ARCHITECTURAL REVIEW BOARD MEETING

3. COA 26-16: 22 Waterloo Street

STAFF REPORT

Meeting Date:	June 25, 2026
Agenda Title:	COA 26-16 22 Waterloo Street
Requested Action:	Proposed Rear Addition, Door Replacements, and Façade Improvements
Department / Agency Lead:	Community Development
Staff Lead:	Whitney Burgess, Preservation Planner

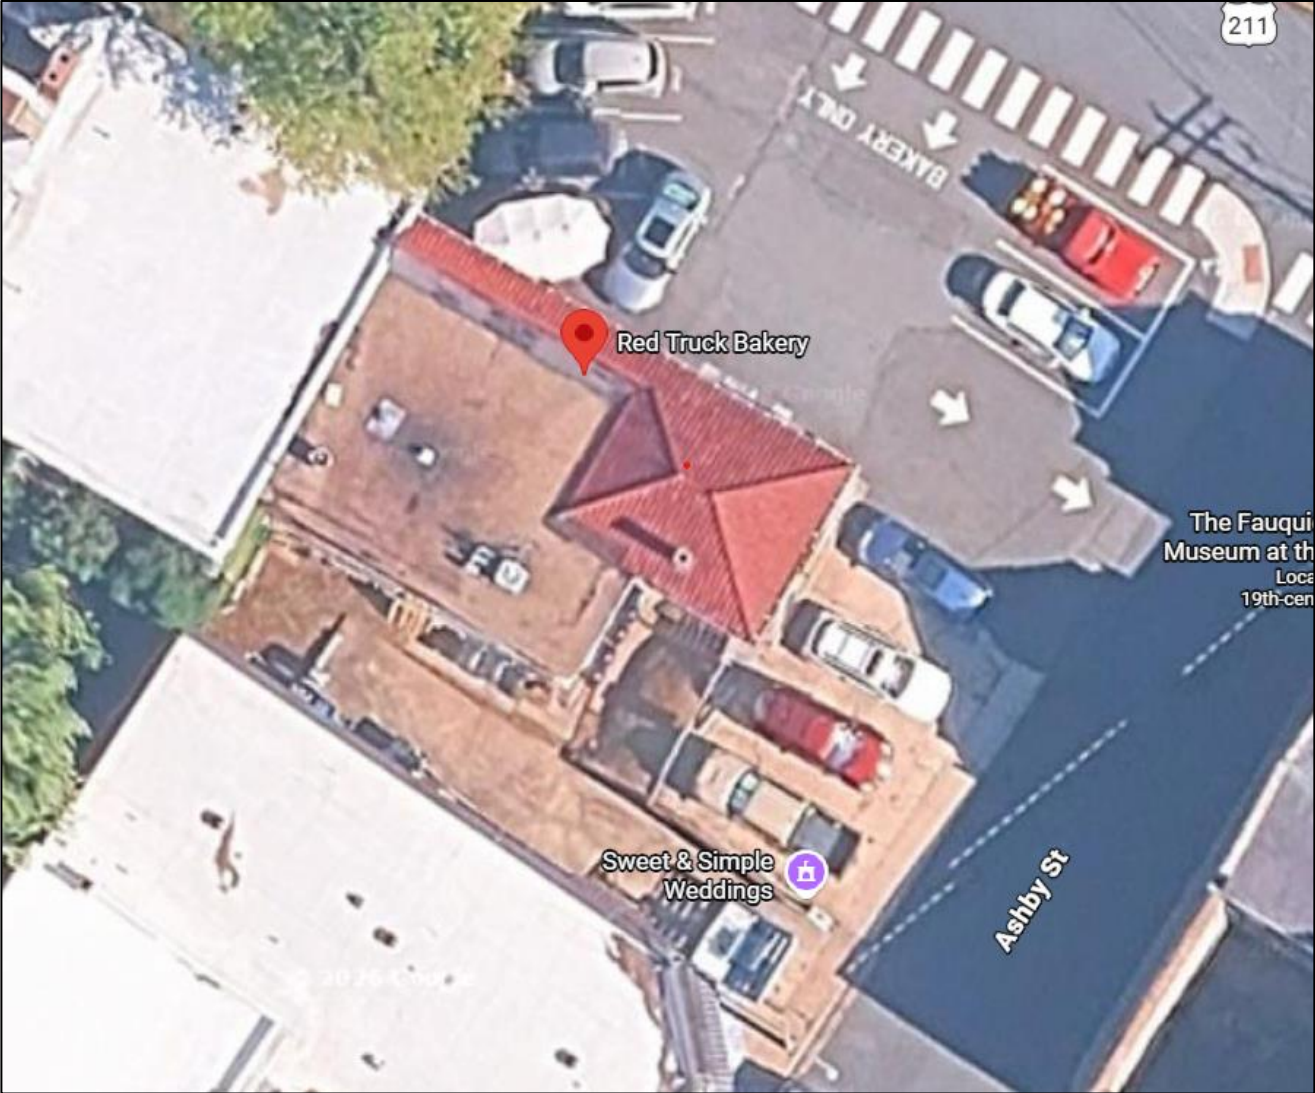
Prior Feedback from Work Session 5/28/2026:

- Incorporate parapet construction at the roofline to provide a buffer to conceal any roof-mounted HVAC, set back 4-5 ft while maintaining the roofline. Avoid replicating the appearance of the historic tile roofing.
- Maintain the current fenestration pattern and in-set (plane) of the garage doors to the greatest extent possible when choosing replacement access doors. Although the extant garage doors are wood, metal or steel doors would be an acceptable option.
- Return to the use of stucco on the exterior of the new addition, but with a different variant or texture than what is on the existing building.
- Include a detailed plan of the "cellar" area within the new addition.

Staff has confirmed that ARB feedback from the Work Session was incorporated into the most recent plans (see Attachments 1 and 2).

Section C

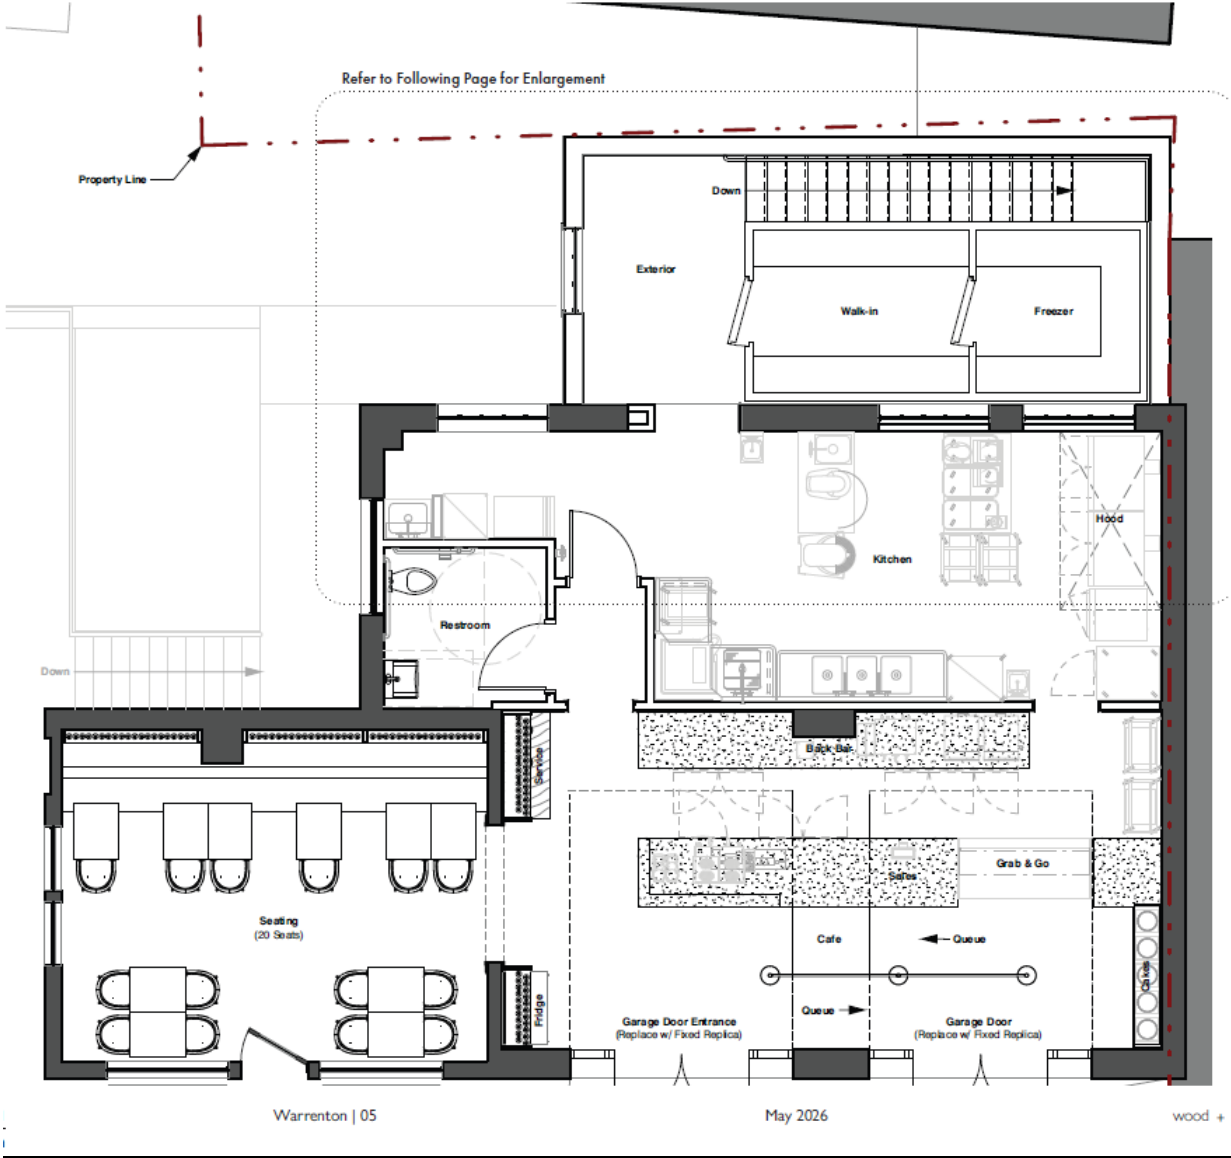
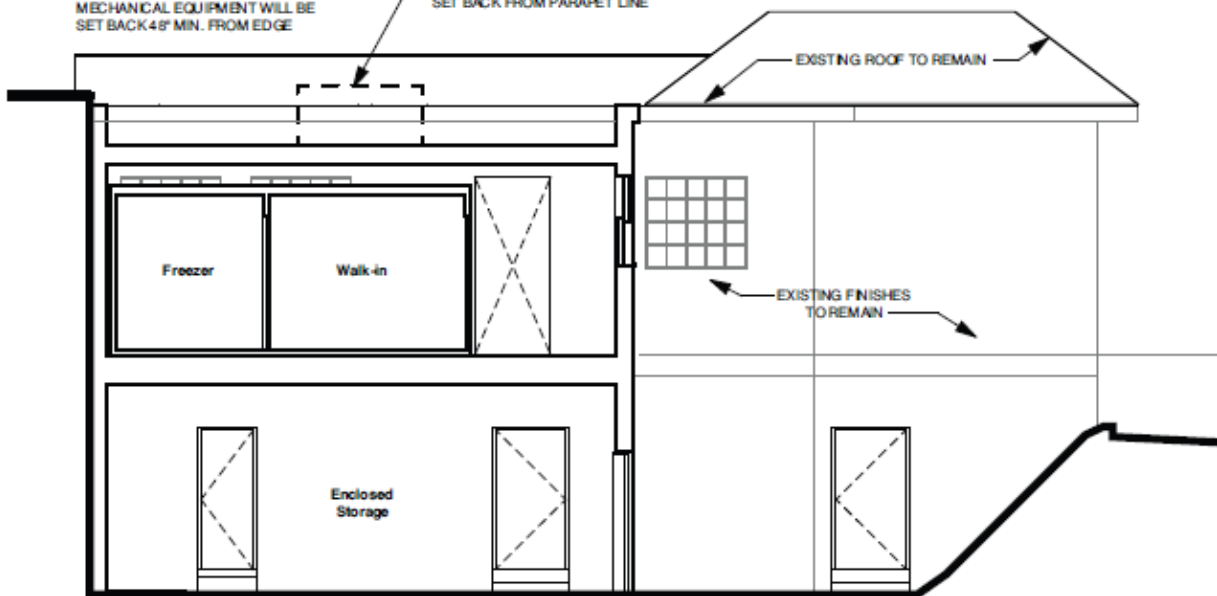
Mr. Beidler asked about any HVAC equipment and proposed a parapet wall on the rear/side elevations to conceal all utilities – would not support tile, but maybe a simple stucco parapet wall.

The contractor asked if an inset parapet would be appropriate, as long as it's set back 4-5' and maintains the current roofline design.

NOTE: ANY CHANGES TO ROOF TOP MECHANICAL EQUIPMENT WILL BE SET BACK 48" MIN. FROM EDGE

WALK-IN MECHANICAL EQUIPMENT SET BACK FROM PARAPET LINE

Current Plan and Concepts

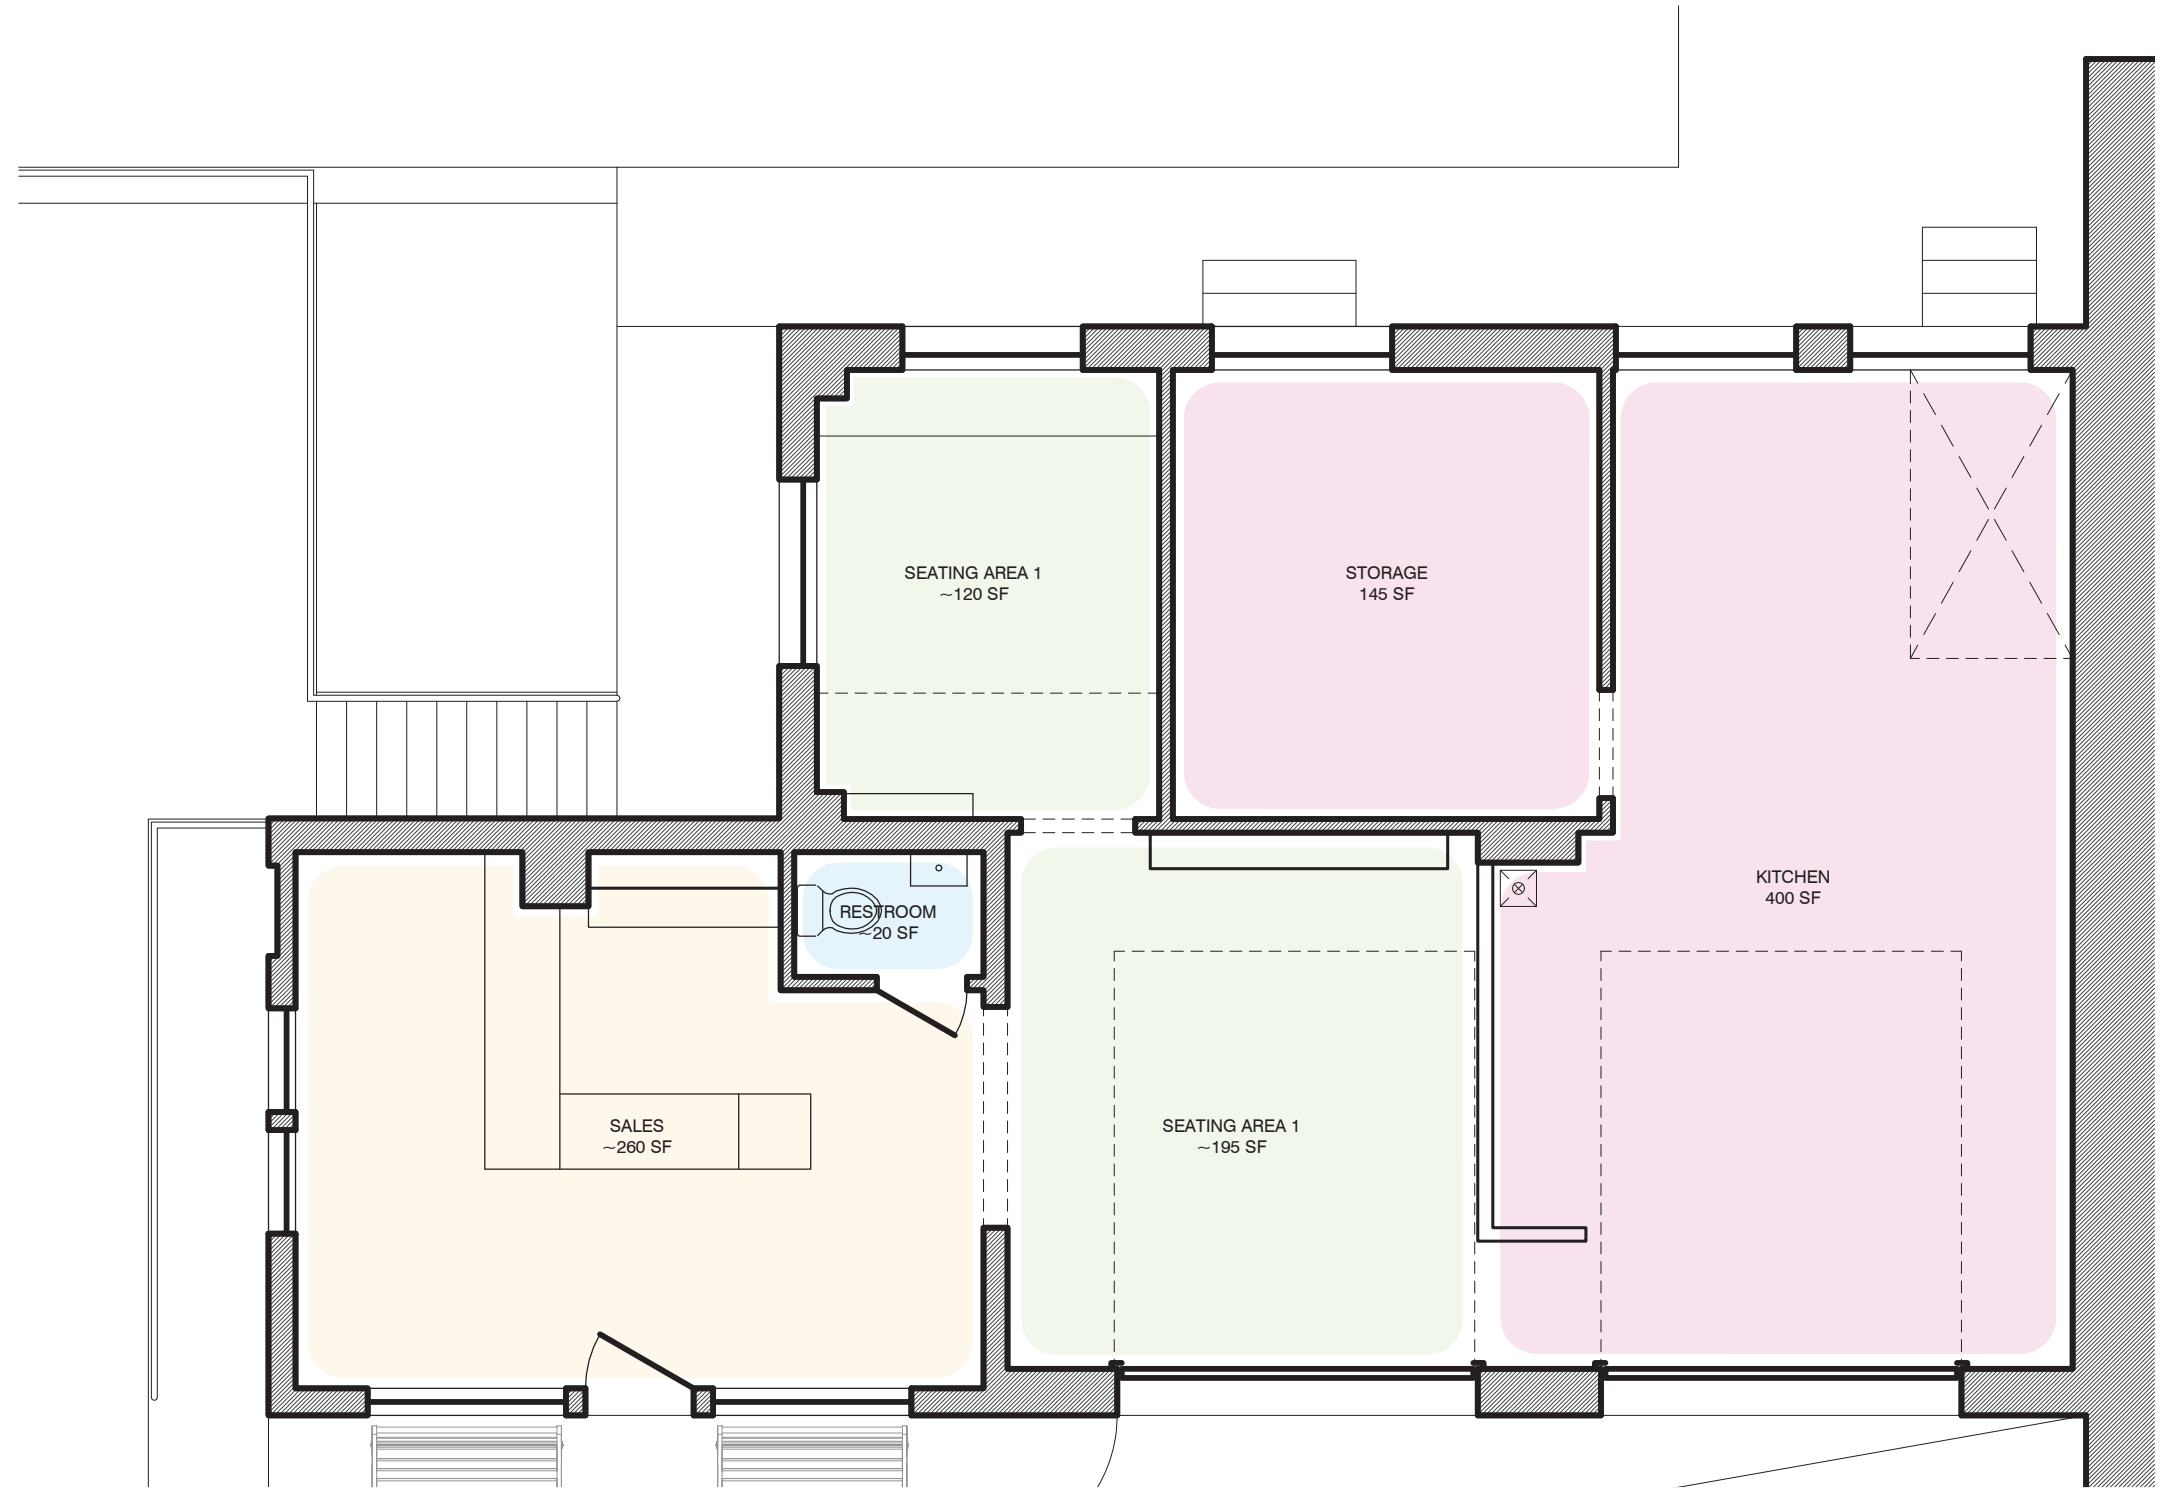
Mr. Burch asked if it would be possible to replicate the doors and windows as to what it looks like right now, not slightly different as the AI rendering shows. The doors would not still need to be non-fixed.

Mr. Scoggin stated that the current proposal seems to detract from the historic value of the building and to maintain the current scale of the doors.

Mr. Hemmingson stated that the proposed layout seems agreeable but agreed that the current scale of the garage doors should be maintained, as seemingly shown in the draft drawings.

Staff recommends approval of Certificate of Appropriateness 26-16 for the request to construct a rear addition to the existing building, and exterior improvements including the replacement of existing garage bay doors with new double-leaf doors of similar configurations and improved exterior lighting, as described and depicted in the application and plans, provided the following conditions are met:

- 1) All necessary permits are acquired;
- 2) The new addition is visually distinguishable from the existing historic materials but respectful of the building's historic character;
- 3) The replacement facade doors respect the historic configurations, plane, and scale of the existing historic garage bay doors;
- 4) Proposed new lighting should be compatible with the historic resource and neighborhood;
- 5) Any new plantings, as part of proposed landscaping changes, should be planted or contained at least 4 inches away from the exterior walls.
- 6) Use appropriate paint finish for the building's stucco exterior, as outlined in the NP Preservation Brief 22: *Preservation and Repair of Historic Stucco*, such as limewash or cement-based paint, latex paint, or oil-based paint.
